Product Change Notification

Product-Series	HWS80A + HWS100A
Product in Detail	all HWS80A including options and submodels like /HD, /ME, /A all HWS100A including options and submodels like /HD, /ME, /A
Subject	Small dimension increases to HWS80A and HWS100A to improve vibration performance
Effective from	October 2023

Details:

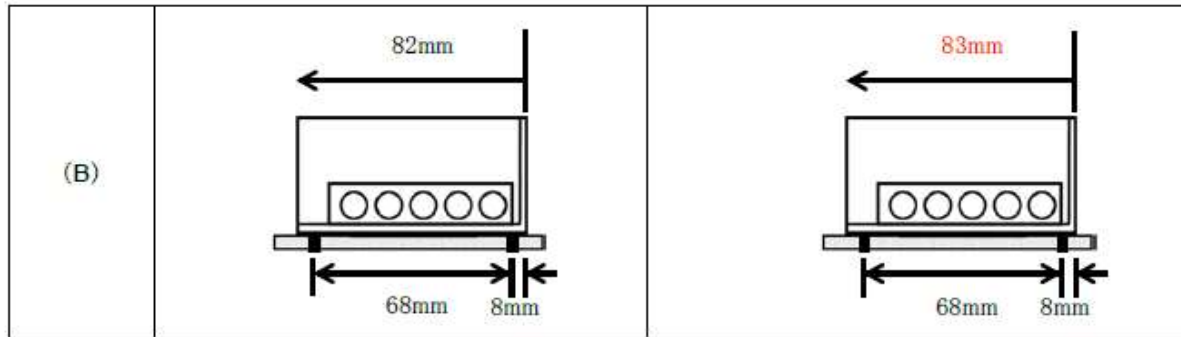
There will be a small dimension increases to TDK-Lambda's HWS80A and HWS100A series of AC-DC power supplies to improve vibration performance. The change will affect **all** models of HWS80A and HWS100A, including all options and submodels. There is no change to product price, function or mounting hole locations and our current standard safety certifications are not impacted. Note that in EMEA the HWS80A model is not traditionally sold or offered.

HWS80/100A	Before Change			After Change		
	Width (W)	Height (H)	Depth (D)	Width (W)	Height (H)	Depth (D)
No cover	28	82	160	28.5	83	160.5
With cover /A	33	82	160	33.5	83	160.5

The positioning of the mounting holes will not change and the unit should not be covered without any free space. In this case we don't think that customers should get any trouble with the increased dimensions. Customers should be informed about the change in dimensions. The documents on the web are already updated.
